PLANNING AND COMMUNITY DEVELOPMENT STAFF REPORT

PLANNING COMMISSION AGENDA ITEM # 3: DPF-09-05	
Project Name:	Fairfield Inn (Indian Meadows, F2, Lot 5)
Prepared By:	Bob Keenan, Senior Planner, (ext. 260)
Through:	Tom Leeson, AICP, Director of Planning and Community Development (Ext. 244)
Planning Commission (PC):	February 25, 2010
City Council (CC):	March 16, 2010
Zoning:	Community Commercial (CC)
Applicant:	Applicant: Bobby Amin 3200 South Lincoln Avenue Steamboat Springs, CO 80487 Phone: 870-9000
Request:	Development Plan/Final Development Plan (DPF) to add 22 hotel rooms to the existing Fairfield Inn with 2 variances: side setback and snow storage.

1 SITE PLAN
SCALE: 1" = 20'-0"
RE: SURVEY

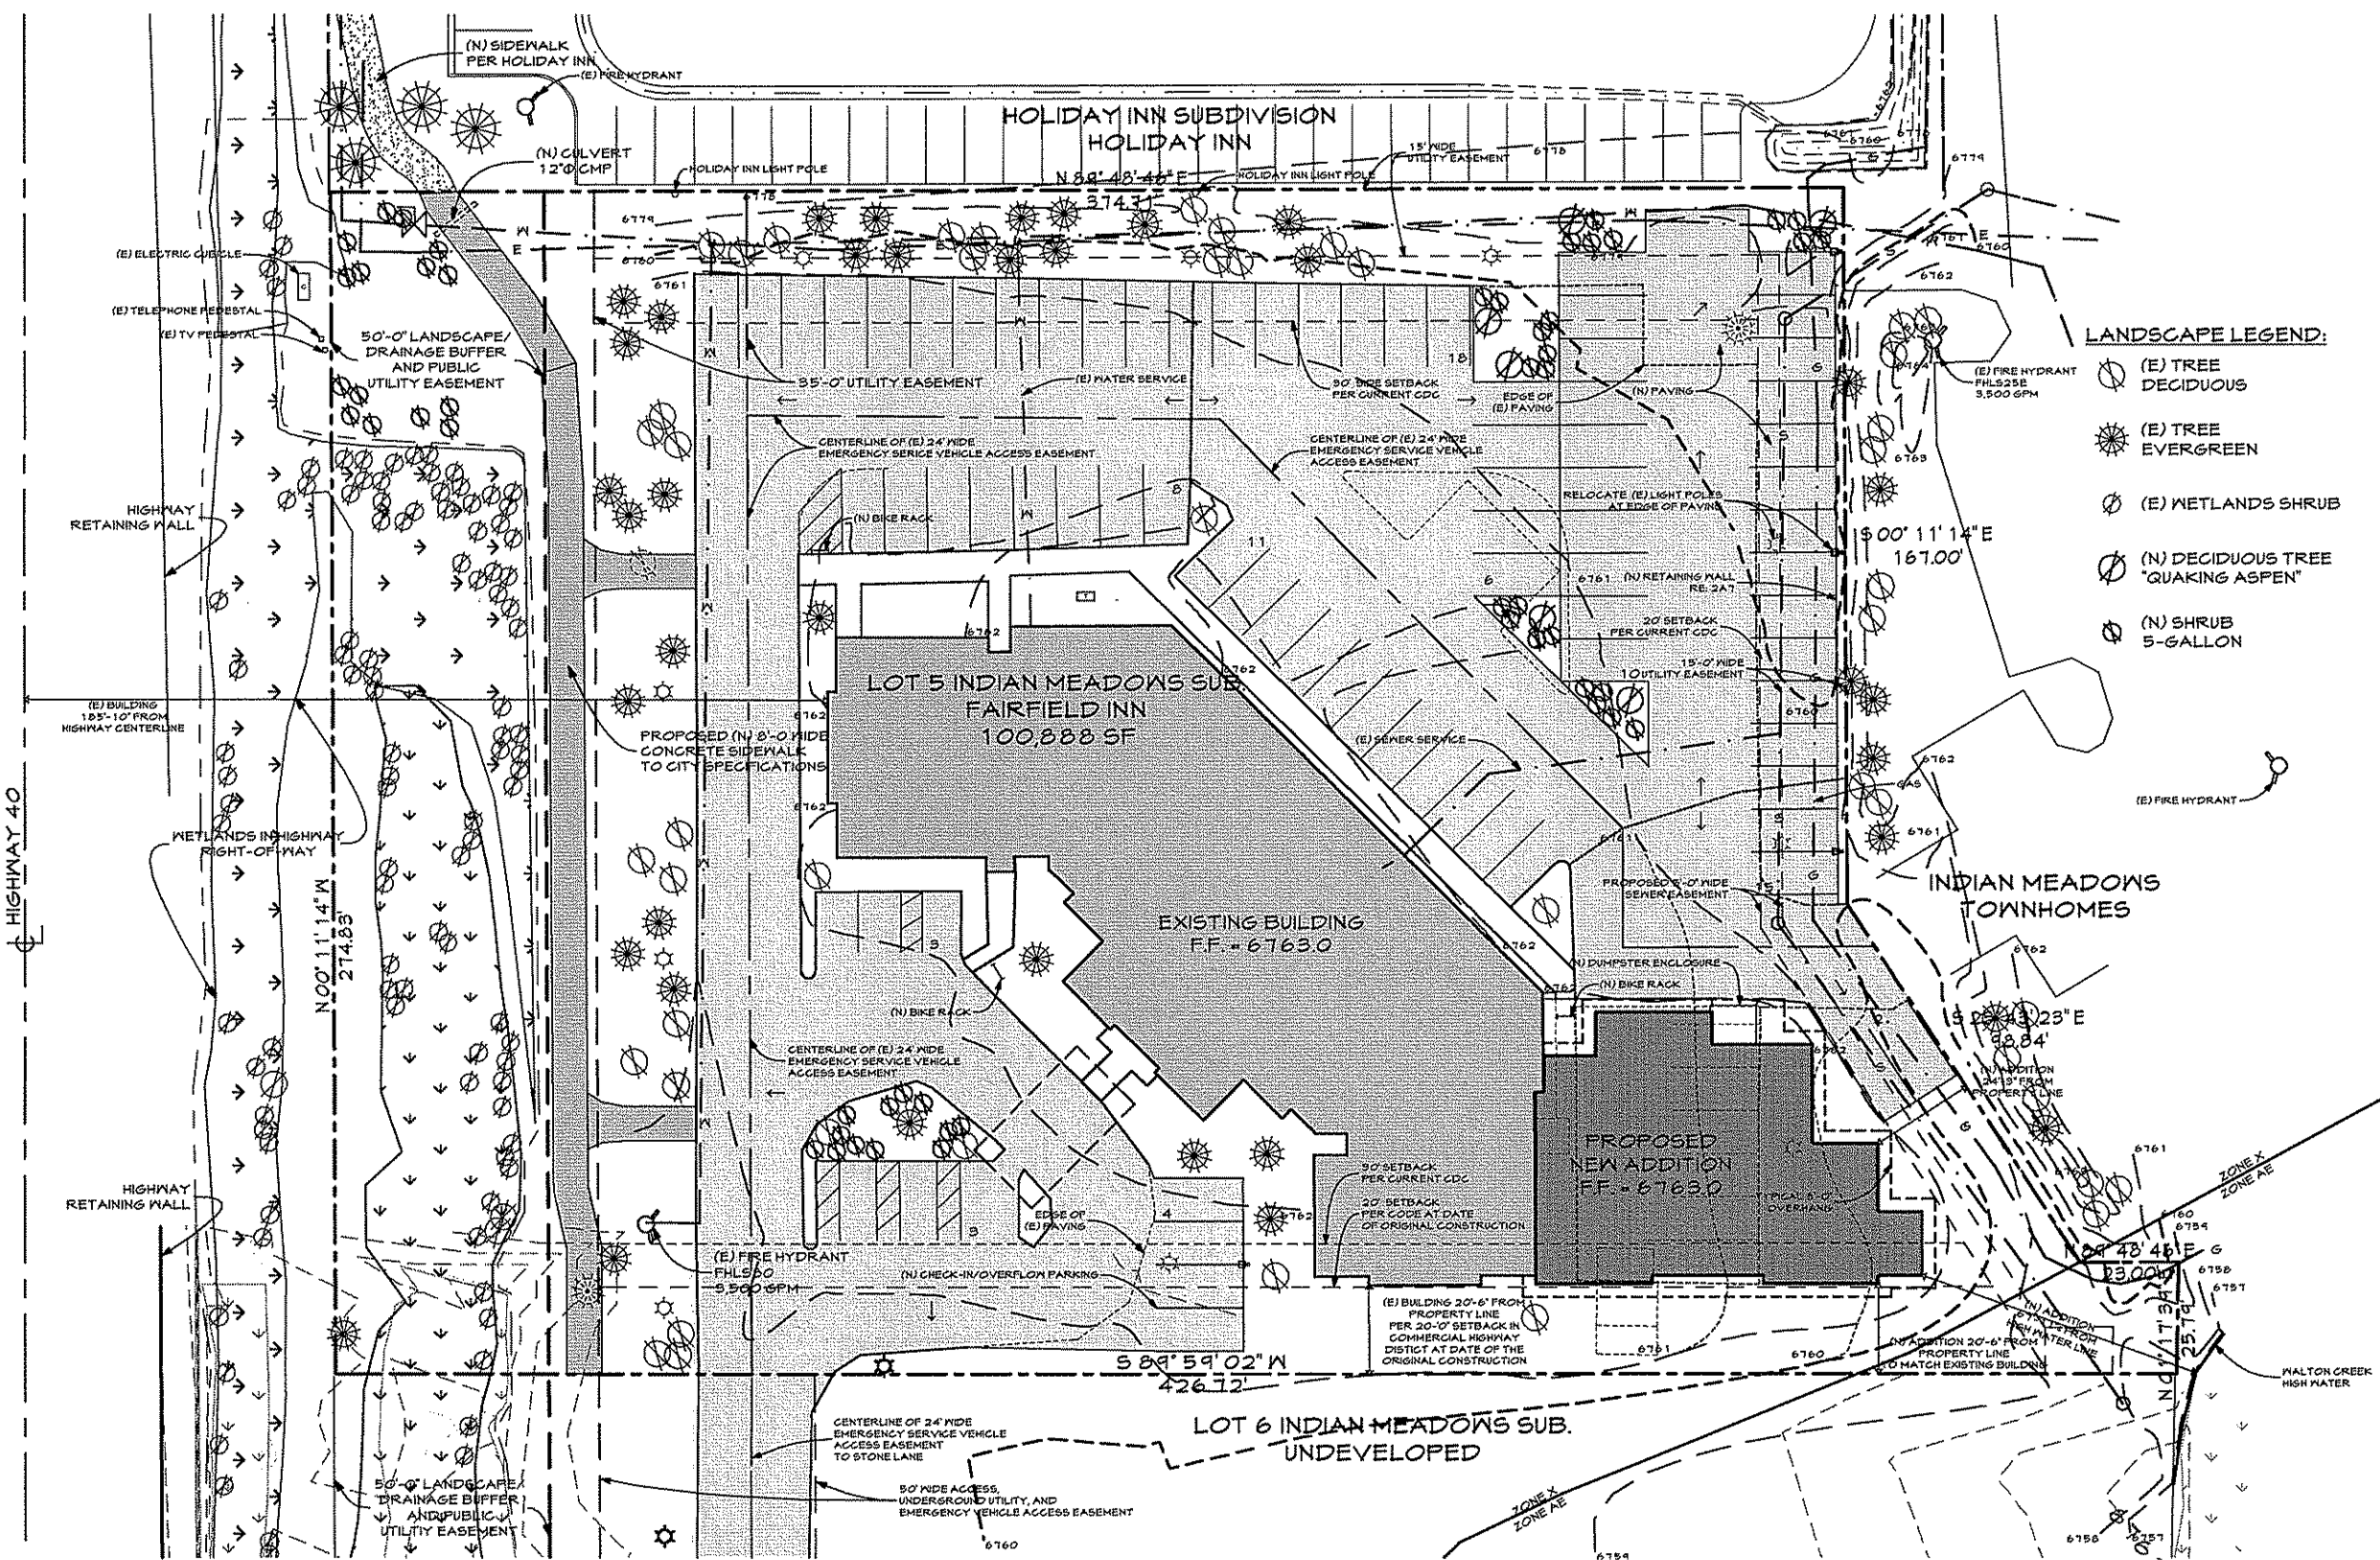
Side Setback - The applicant is also requesting relief from the 30’ required south side setback. The existing building is currently setback 20’ 6” from the side property line and the applicant wishes to continue with the existing setback. It is important to note that this was not a variance at the time the existing building went through the application process.

Staff Analysis: **Consistent;** Staff finds that the proposed setback encroachment of 9'6" into the required 30' south side setback should not have any negative impacts to adjacent properties. The adjacent property to this setback is also zoned CC and is currently vacant. The proposed encroachment is consistent with the existing hotel side setback.

Staff Analysis: **Consistent;** Staff finds that the advantages of allowing the setback encroachment outweigh any disadvantages. Allowing for a reduced setback helps accommodate the proposed addition while not losing parking spaces or encroaching the Emergency Access Easement. Moving the building to the 30' side setback could mean the loss of parking spaces which would require a variance. The proposed location

We are requesting a variance to the south setback line to allow the new addition to be built as an extension to the existing building. When the original building was constructed in 1998, it was located in the 'Commercial Highway Zone District' which required 20' side setbacks. The existing building is located 20'-6"± from the south property line. The zoning has since been changed to 'Community Commercial' which requires 30' side setbacks. We are requesting a variance along the south property line to allow us to build to the original 20' setback to match the existing construction, per drawing 1A2. The new addition will conform to all other current setbacks.

1 SNOW STORAGE PLAN
SCALE: 1" = 40'-0"
REF: 1A2

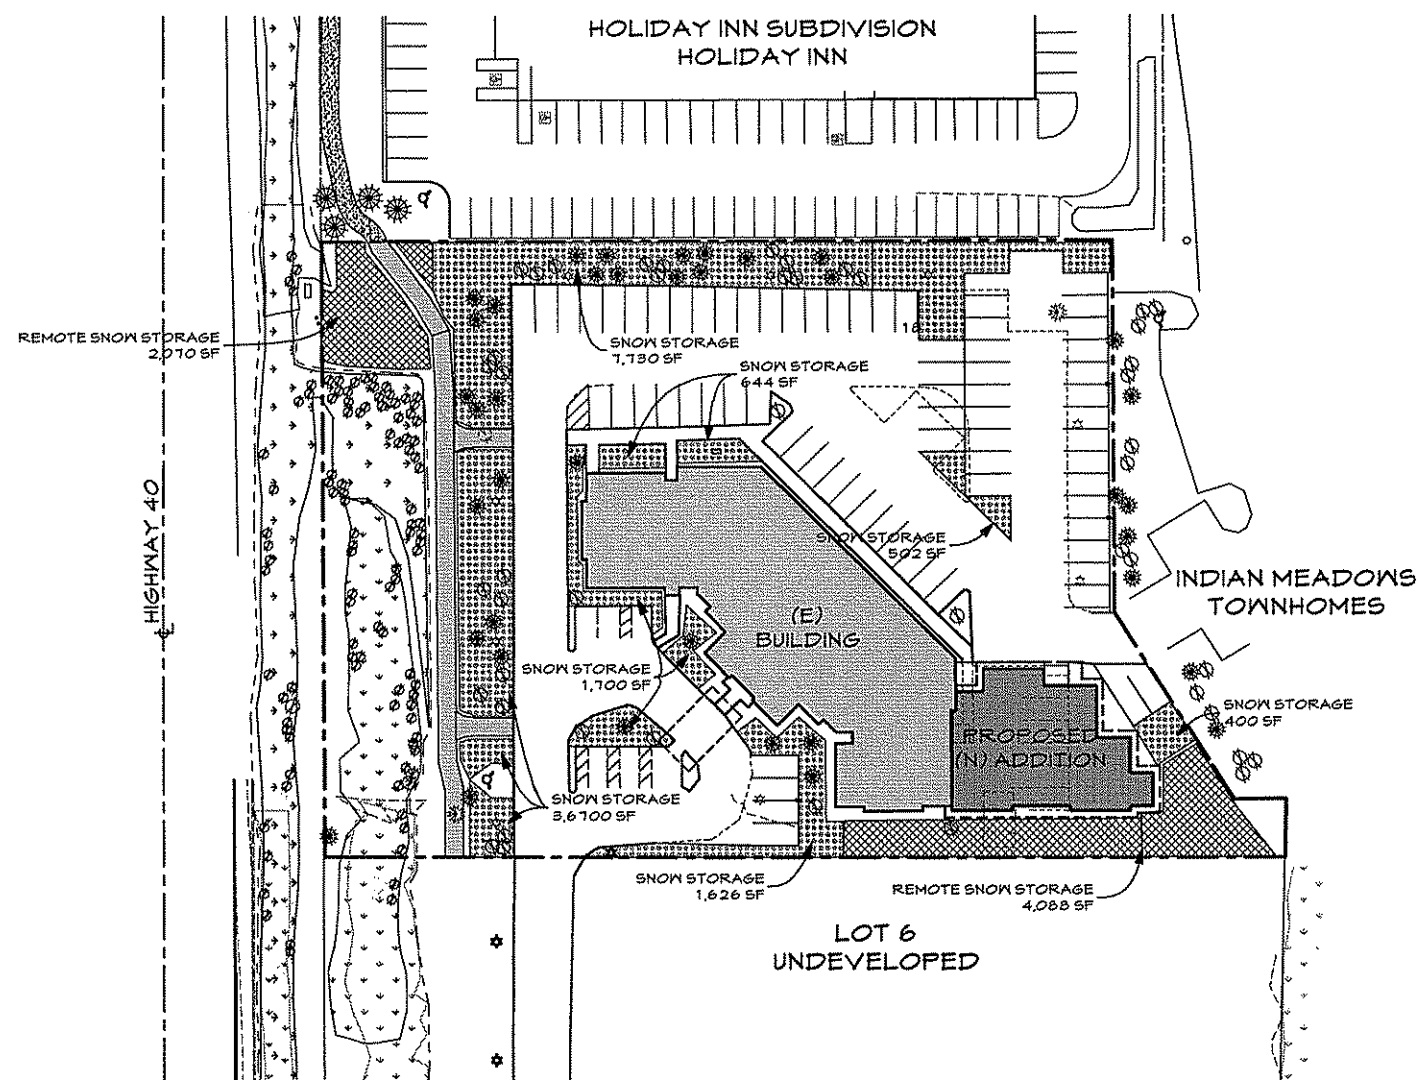
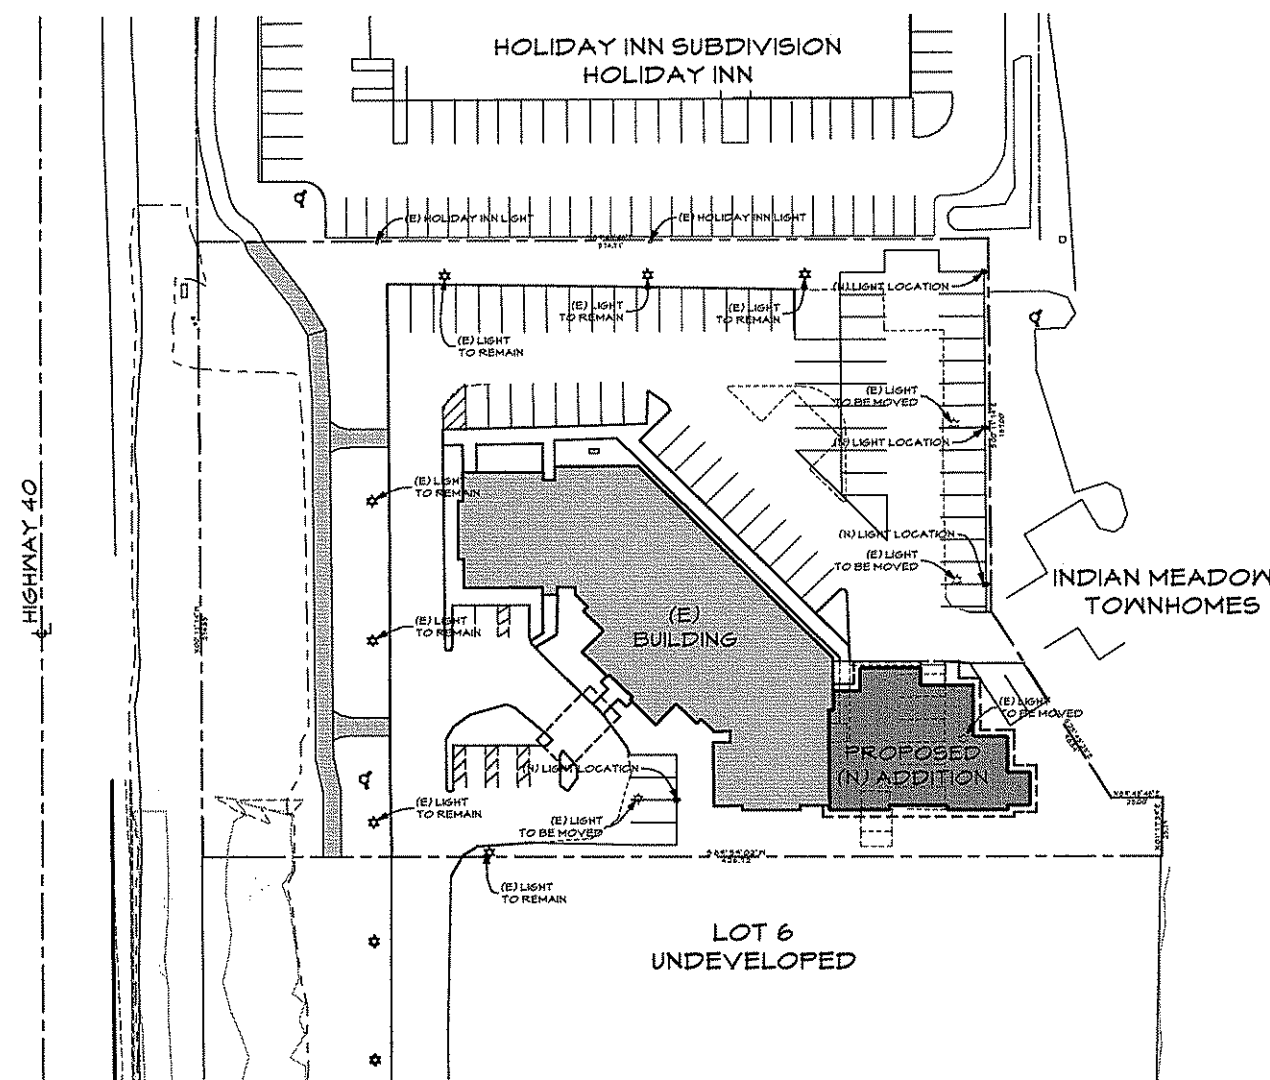
Snow Storage – The applicant seeks relief from the amount of snow storage area to be provided due to the lack of area to accommodate the required storage. The applicant plans to haul snow as needed and store snow in areas in excess of 20’ from pavement.

Staff Analysis: Consistent; Injury to adjacent property is not anticipated with the snow

storage variation. The applicant plans to haul snow or store snow in areas greater than 20' from pavement, where appropriate.

Staff Analysis: Consistent; The advantages of increased building intensity and hotel rooms in our commercial zone districts outweigh any disadvantages to snow hauling and blowing.

We are requesting a variance to the required snow storage area to allow for snow removal to on-site 'remote snow storage.' In the Community Development Code, snow storage is defined only as being within 20' of paving. Due to the layout of the existing building, existing paving, and existing emergency access easements, we cannot get the required snow storage area within 20' of paving. We do, however, have adequate 'remote snow storage' in areas that are beyond 20' from paving, per drawing 1A6. With our heavy snow, snow removal will move excess snow to the remote storage areas first and build back to the edge of paving. Should off site removal be required, the owner will contract that additional snow removal.

On-site remote snow storage will serve as a supplement to regular snow storage areas, not as a replacement. The proposed development provides nearly 80% of the required snow storage in areas within 20' of paving.
